Tennessee Valley Authority, 1101 Market Street, Chattanooga, Tennessee 37402

CNL-14-068

Subject: Browns Ferry Nuclear Plant (BFN), Units 1, 2, and 3 - Supplement to Proposed Technical Specification Change to Revise the Leakage Rate Through MSIVs (TS-485)

TS-485 Supplement 1

BFN Primary "ALT" Pathway from Main Steam Lines to Condenser

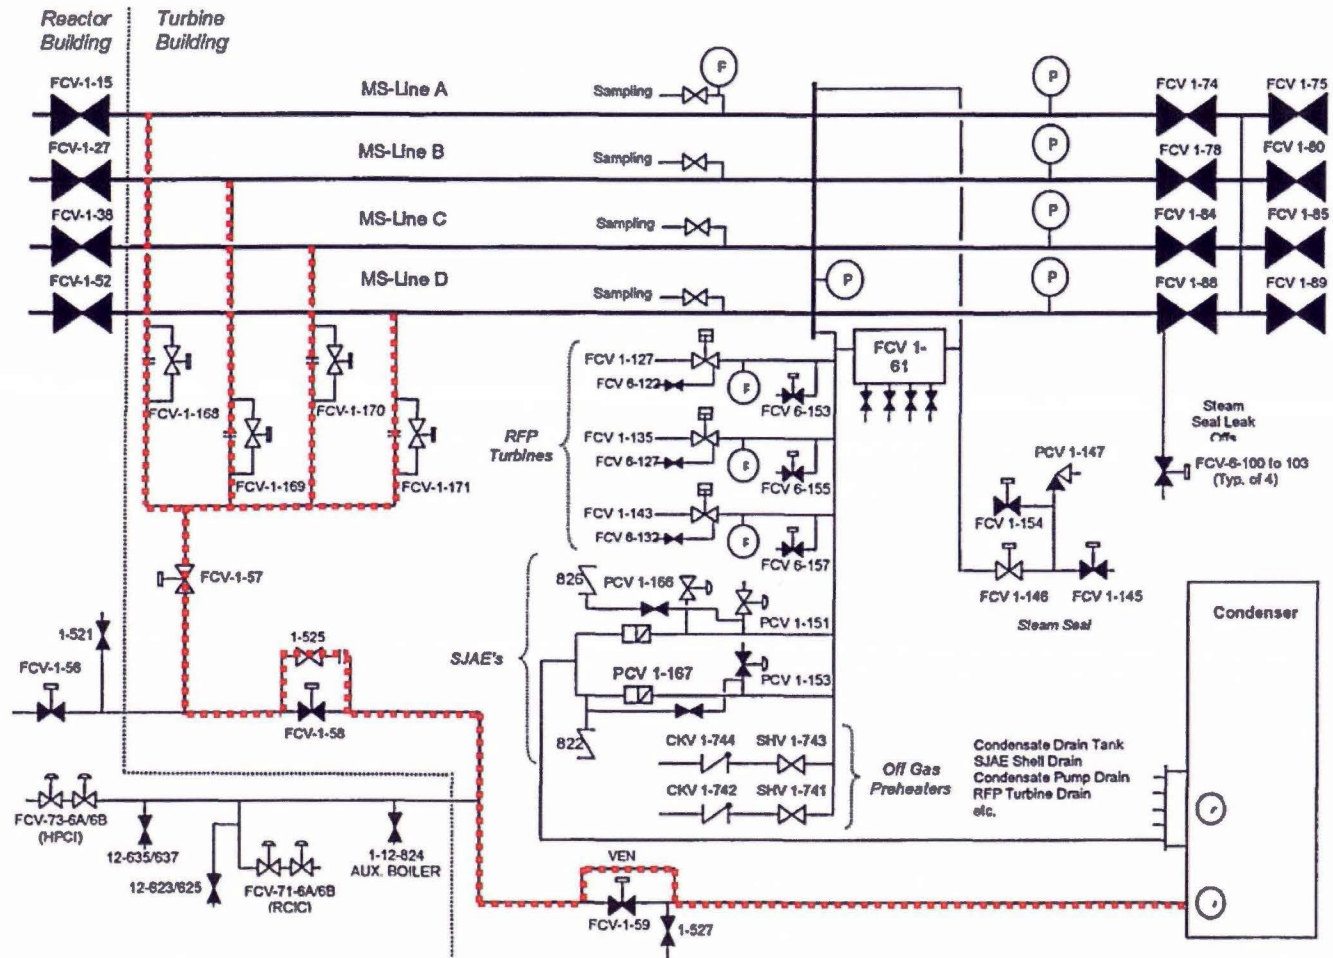
The primary ALT Pathway is proposed to be defined as the passive pathway through the orifice bypass lines around each of the main steam drain lines, through open valve FCV-1-57, through the orifice bypass line around valve FCV-1-58, and finally through a non-orifice bypass line around valve FCV-1-59 to the condenser (Figure 1). The secondary ALT Pathway is proposed to be the pathway through normally open valves FCV-1-168, FCV-1-169, FCV-1-170, and FCV-1-171, and continues through valves FCV-1-57, FCV-1-58, and FCV-1-59 to the main condenser (Figure 2). The use of a

The primary ALT Pathway is based on the flow path through the orifice bypass lines around each of the main steam drain lines, through open valve FCV-1-57 (which will have its power removed), through the 0.1875-inch orifice bypass line around valve FCV-1-58 and the four inch bypass line around FCV-1-59 for those events taking credit for the availability of the ALT Pathway to the condenser. The primary flow path from the MSIVs to the condenser continues to be passive, requiring no operator actions or valve positions to change to establish the pathway. This primary flow path consists of the following:

- Four outboard MSIVs through 24-inch lines connecting to two-inch drain lines from each MSIV.
- Four two-inch bypass lines, that contain 0.25-inch orifices (around valves FCV-1-168, FCV-1-169, FCV-1-170 and FCV-1-171), connecting to a three-inch header.
- The three-inch header through normally open, with power removed, valve FCV-1-57 to a three-inch tee.
- The three-inch tee through a one-inch bypass line (around the normally closed valve FCV-1-58) that has a 0.1875-inch orifice and a normally open manual blowdown valve (BOV)-1-525.
- A four-inch bypass line (around normally closed valve FCV-1-59) to the condenser.

BFN Secondary "ALT" Pathway from Main Steam Lines to Condenser

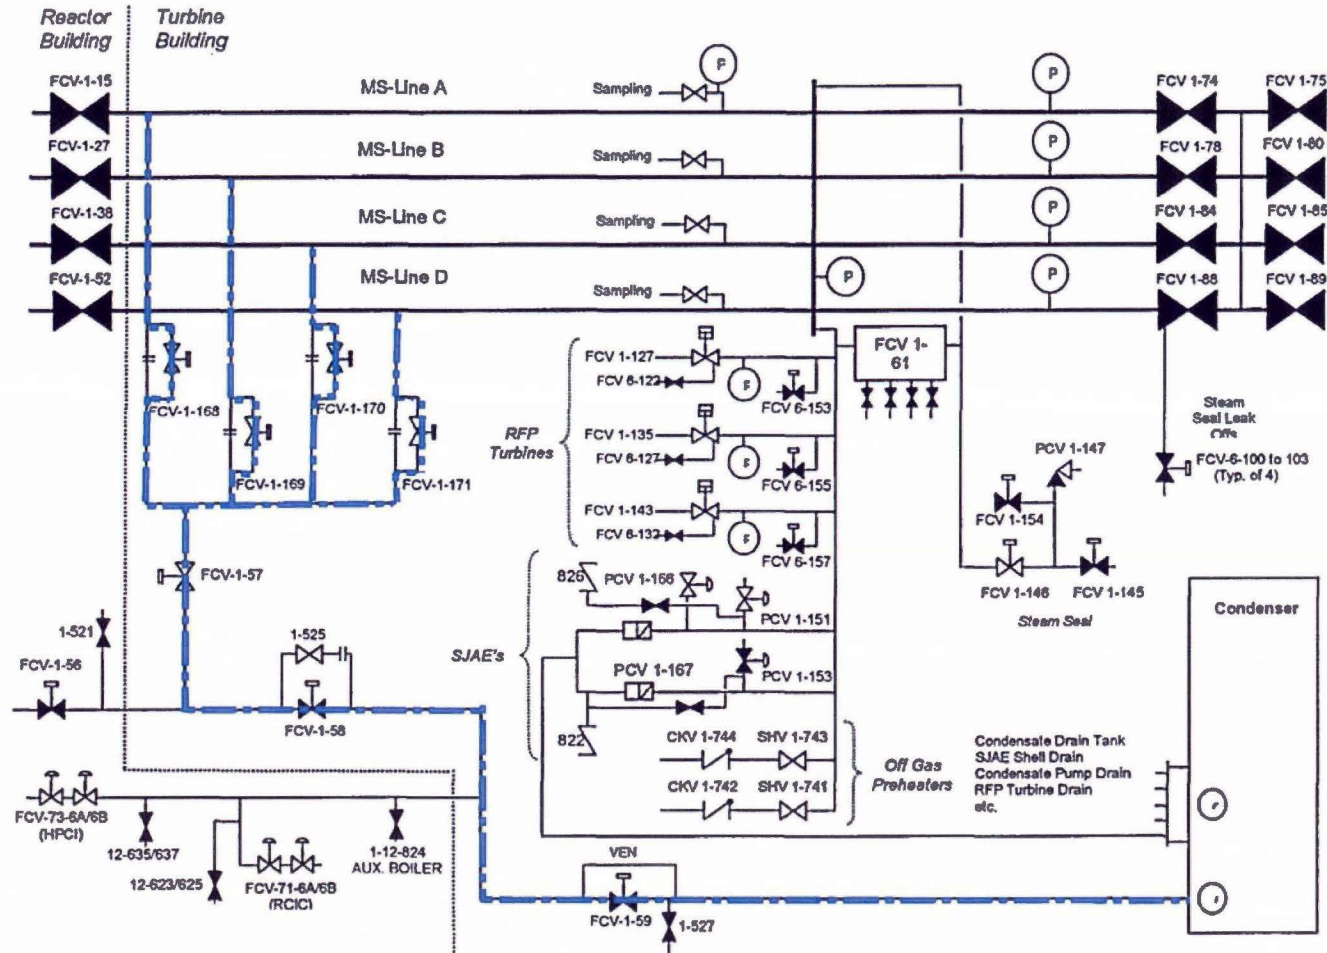
maximum through each MSIV and 85 scfh for the combined leakage rate for all four main steam lines. The secondary ALT Pathway (Figure 2) has now been defined as the pathway through the main steam drain lines and through open valves FCV-1-57, FCV-1-58, and FCV-1-59 to the condenser.

In the unlikely event the primary flow path is not available, and consistent with the guidance provided in NEDC-31858P, a secondary flow path is provided (although not with orifice flow). The secondary flow path is through normally open valves FCV-1-168, FCV-1-169, FCV-1-170, and FCV-1-171, and continues through valves FCV-1-57, FCV-1-58, and FCV-1-59 to the main condenser.

MSIV Seismic Verification Walkdown Boundary

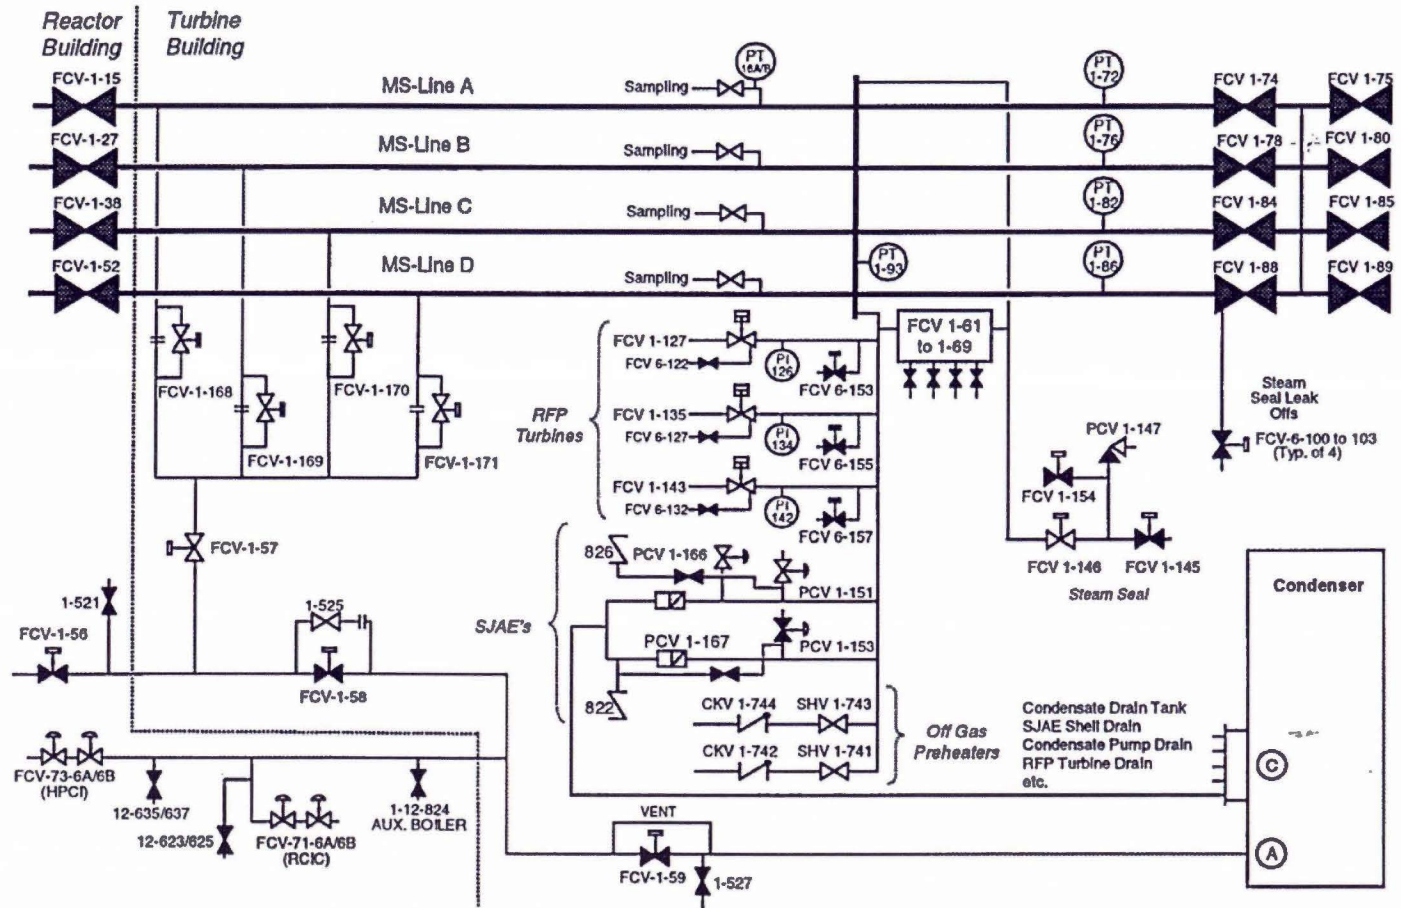
The MSIV Seismic Verification Walkdown Boundary (Figure 3) provides a flow diagram schematic that shows the ALT Pathway from the MSIVs to the condenser and the boundary valves associated with the ALT Pathway for BFN, Units 1, 2, and 3. As discussed in NEDC-31858P, "BWROG Report for Increasing MSIV Leakage Rate Limits and Elimination of Leakage Control Systems," the ALT Pathway establishes a seismically rugged route to contain and direct leakage from the MSIVs to the condenser following a design basis LOCA.

As previously noted, Figure 3 provides a flow diagram that shows the ALT leakage pathway from the MSIVs to the condenser, and the boundary valves. All boundary valves are either closed during normal system operation or fail closed upon loss of power, loss of control air, or hydraulic pressure or close upon line depressurization. All of the boundary valves fall into one of the following categories:
